COMMUNITY DESIGN REVIEW BOARD STAFF REPORT
Meeting Date September 15, 2020

REPORT TO:	Melinda Coleman, City Manager
REPORT FROM:	Michael Martin, AICP, Assistant Community Development Director
PRESENTER:	Michael Martin, AICP, Assistant Community Development Director
AGENDA ITEM:	Design Review, Maplewood Living Development, 0 Maplewood Drive

Maplewood Living Development

SITE PLAN

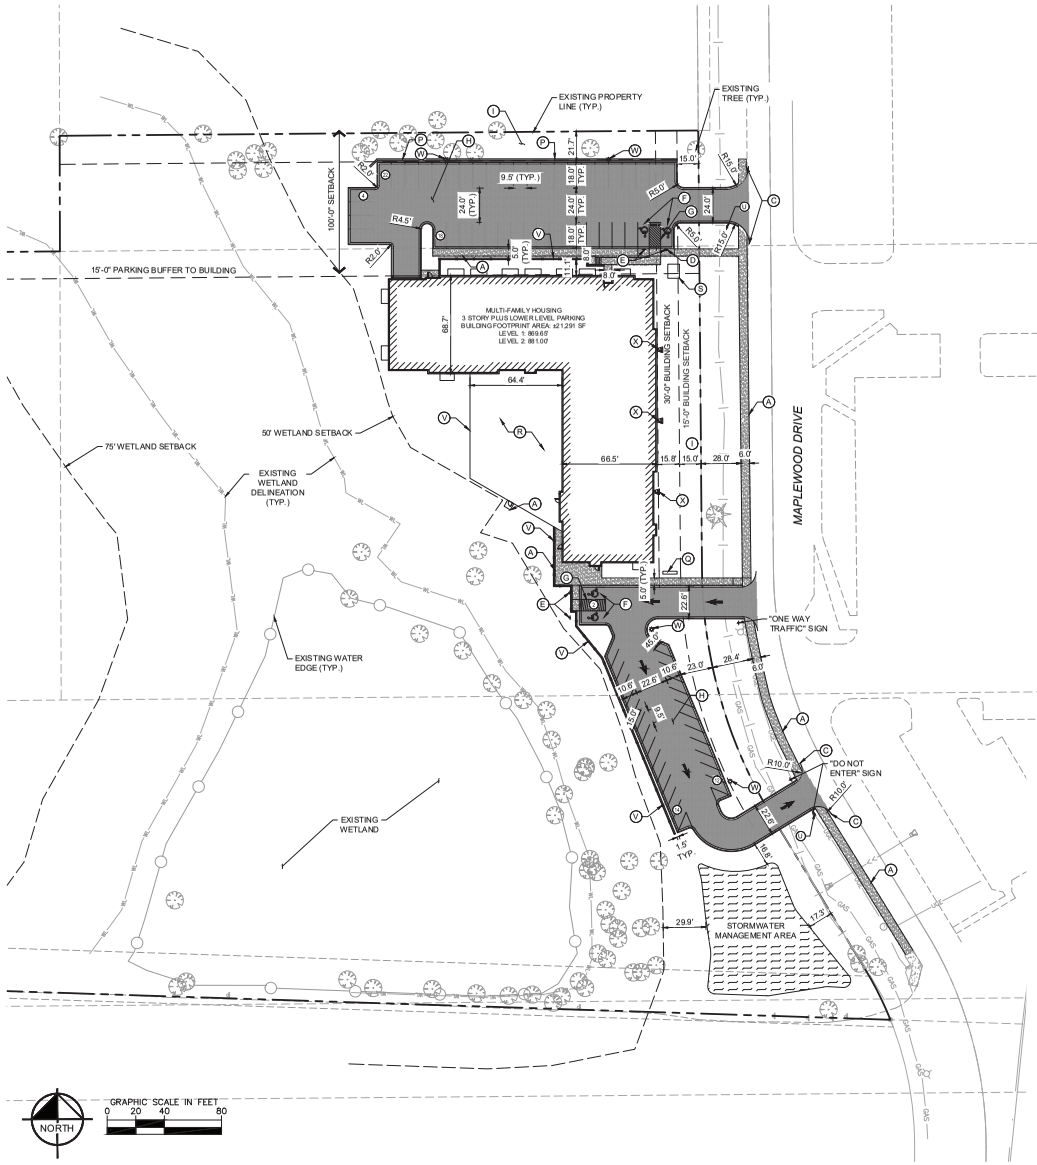
The site will be accessed by three drives coming off Maplewood Drive. A single access point would be north of the building and would lead to the underground garage. Two access points provide access to a one-way drive and parking lot south of the building. The proposed apartment building and parking lots are concentrated on the east side of the lot, preserving buildable land on the west side of the lot. The area of land on the west side of the site, which is also west of a wetland, will not be built on as it is needed for residential density calculations. The building and parking lots meet all required setbacks including the 100 feet setback which is required to the north property line.

I see from the plans the main entrance to the apartment is the parking lot on the north side, along with the garage door on the northwest end of the apartment. My concern is that we will be hearing the cars driving into the lot with the walls of the apartment reflecting the noise. I'm concerned about the noise of the of the garage door opening and closing. With the 9% grade into the garage I worry that our backyards will be lit up with the lights from the cars exiting the building at night.

LANDSCAPE PLAN

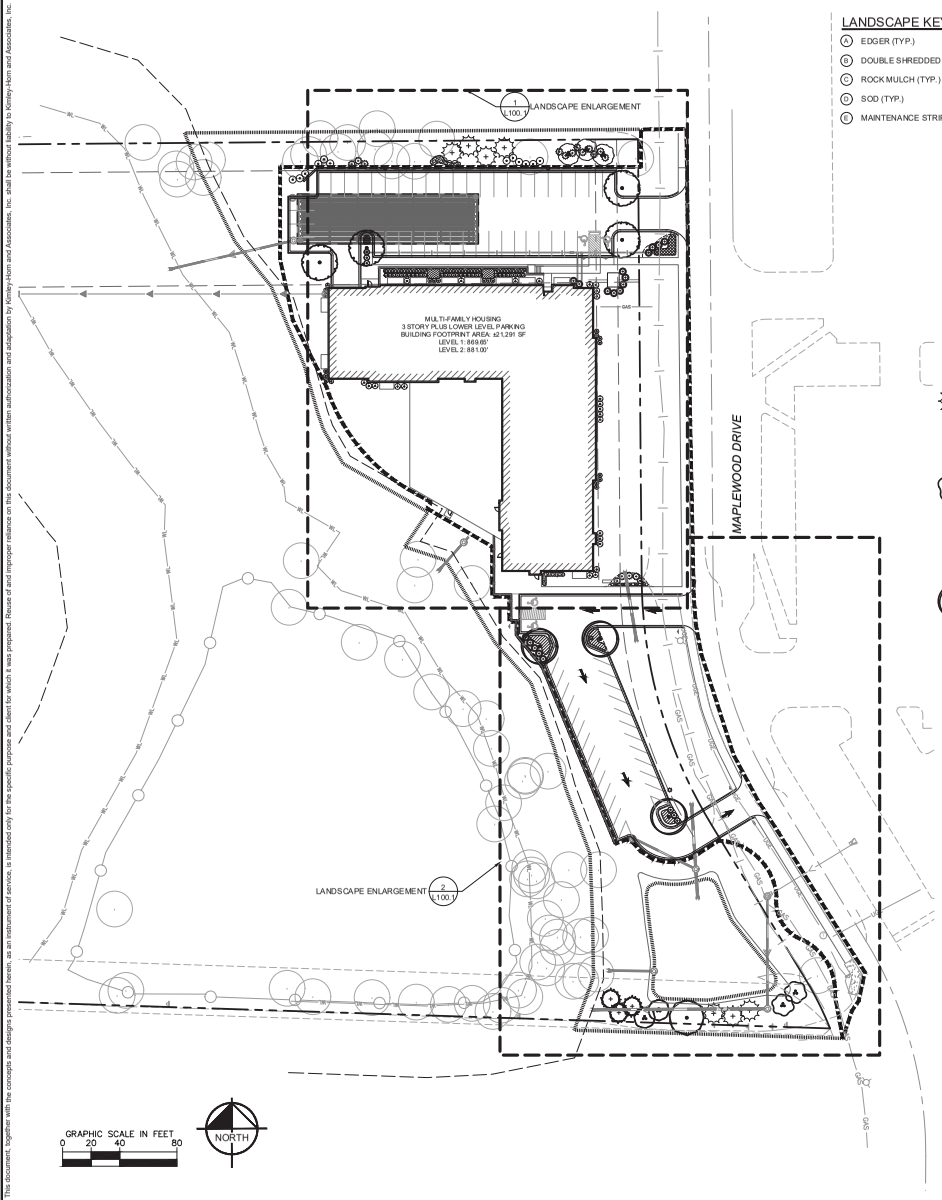
City ordinance requires screening to be installed when light from automobile headlights and other sources would be directed into residential windows – in this case along the north property line in the area of the proposed parking lot. The ordinance states that minimum screening shall consist of a barrier at least six feet in height which provides a minimum opaqueness of 80 percent. If vegetation is used it must provide year-round screening, otherwise, a fence or combination of the two may be used. The applicant's plans do not explicitly show how this screening requirement can be met year-round. Prior to a building permit being issued, the applicant shall be required to provide a plan showing that the screening requirement is met.

3. Tree Replacement: The applicant's landscape plan includes 25 new trees, for a total of 50.5 caliper inches. The required screen area adjacent the single family homes, north of the parking lot, will be planted with four evergreens and three ornamental trees, in addition to shrubs and seed or sod. These plantings will be located in between existing trees that are being preserved. No trees are proposed in front of the building or in front of the south parking lot, adjacent Maplewood Drive. The tree planting meets the City's tree replacement requirements but may not meet the City's landscaping and screening requirements.

1) Landscape Plan: A revised landscape plan showing additional trees or screening north of the parking lot to meet the City's screening requirements. Additionally, the applicant should add trees in front of the building and south parking lot, adjacent Maplewood Drive.

4) Landscape Plan: The landscape plan appears to add turf or seed within the 50-foot wetland buffer located on the east side of the wetland, adjacent the development. The applicant must supply a detailed landscape plan to ensure there is no impact to the wetland buffer.

b. Submit to staff a screening plan detailing that all ordinance requirements are met in terms of screening on the north side of the north parking lot.

1 A201 NORTH ELEVATION
SCALE: 1/8" = 1'-0"

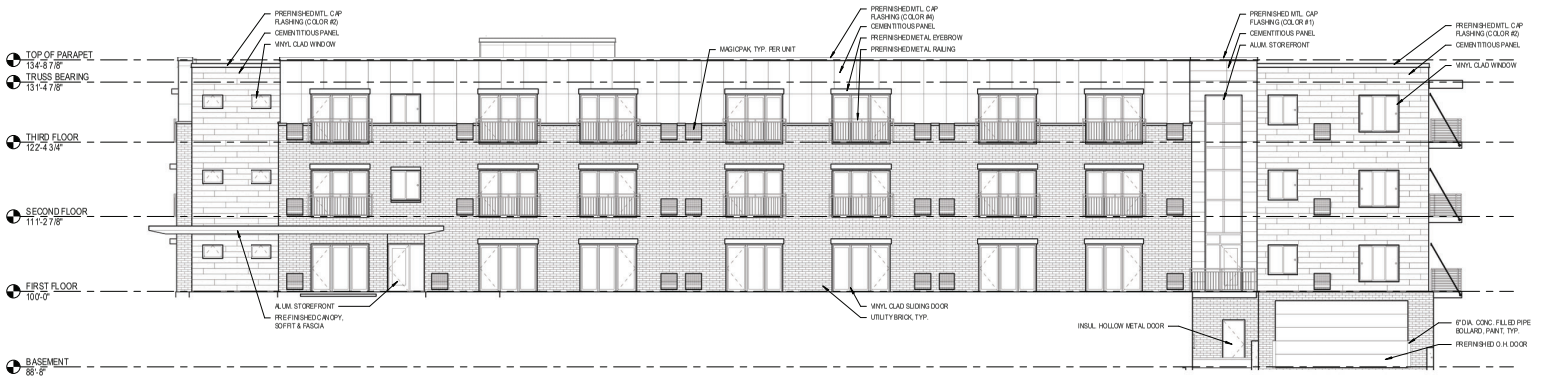
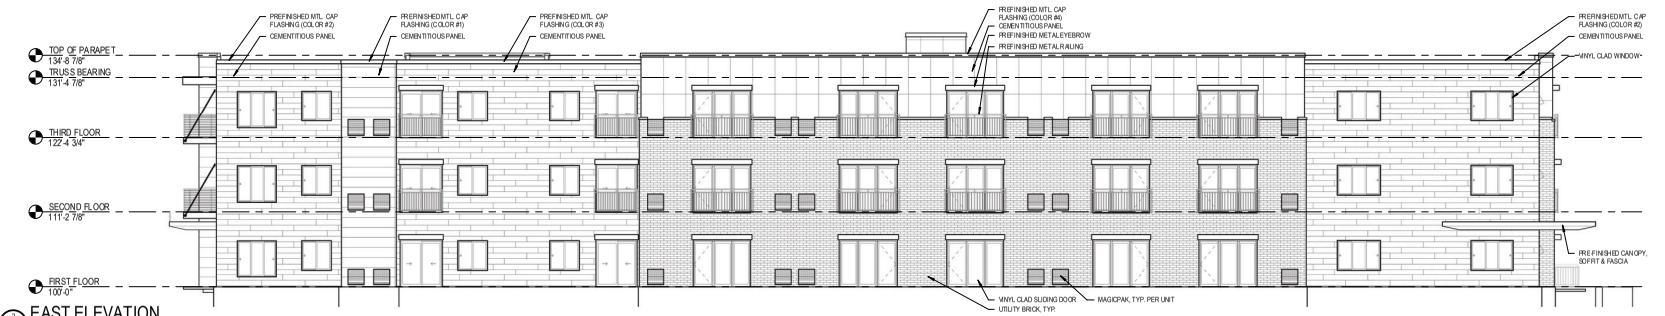
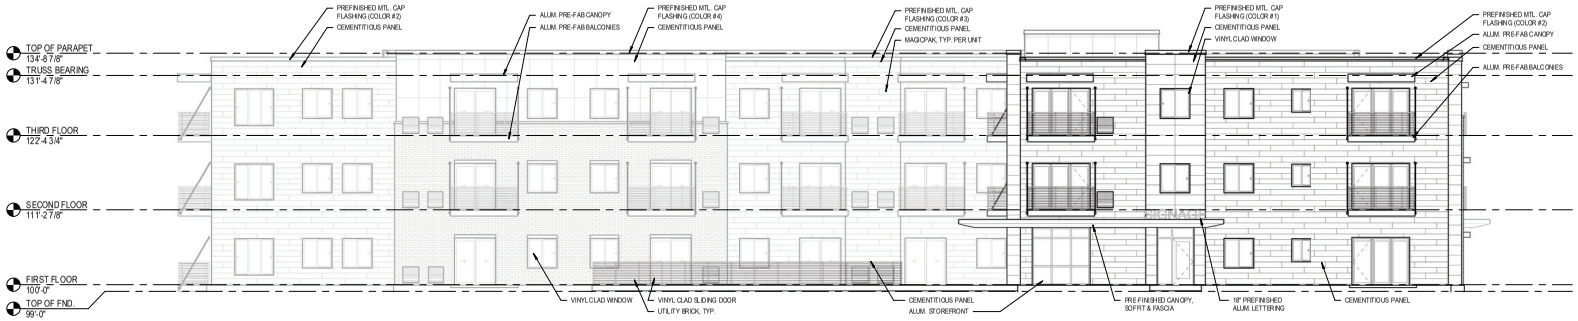
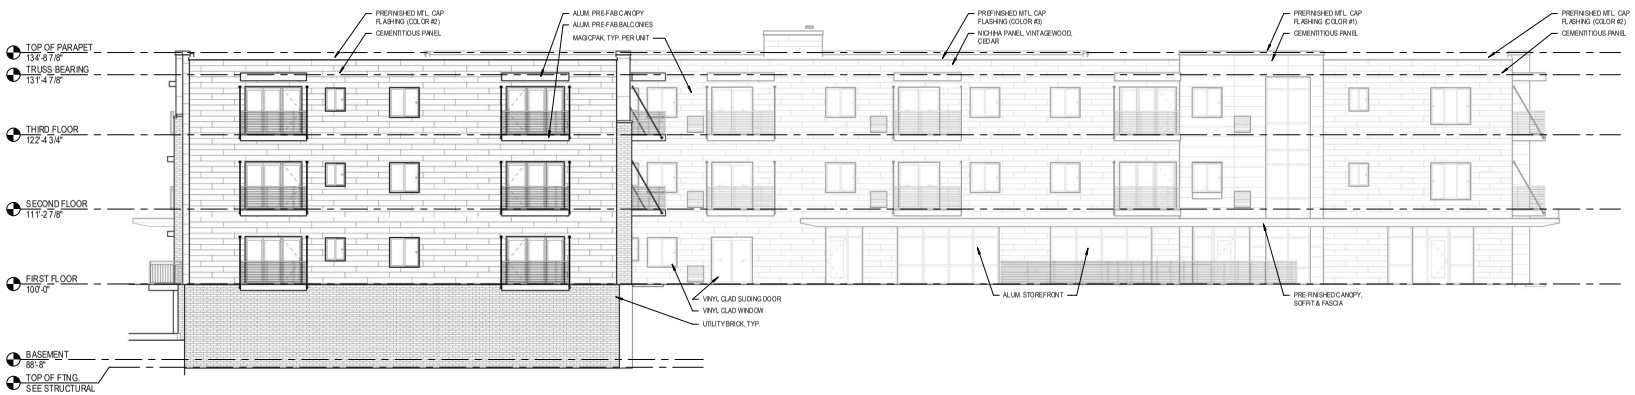
The height of the three-story building is 34' 8 7/8" feet – which meets city requirements. The exterior of the building will be comprised of brick, stone, metal panel and cementitious siding with a flat roof. All rooftop equipment will be required to be screened on all sides.

i. Based on the surrounding neighborhood, three-story building will definitely stick out. There didn't seem to be enough tree coverage to help it blend in at that height and would easily make it the tallest structure, making lighting a concern. It wasn't clear to me what lighting would be included in the design and have reservations on how visible / disruptive it would be given the current neighborhood.

7. Overall I think the plan looks good. It seems to save the wetland areas and the ponding areas. Which is good. Any place with a dog washing station has to be a nice place! The buildings look a little dark and foreboding to me, but I don't know what current architecture looks like. Maybe they could be a little brighter? I think the whole thing could be moved another 20 to 30 feet south so as not to be so close to the homes on County Rd C. I also hope that there will be some trails down around the pond for those dog owners to walk their dogs. (Donald Christianson, 1111 County Road C East)

6. Rooftop vents and equipment shall be located out of view from all sides of the property.
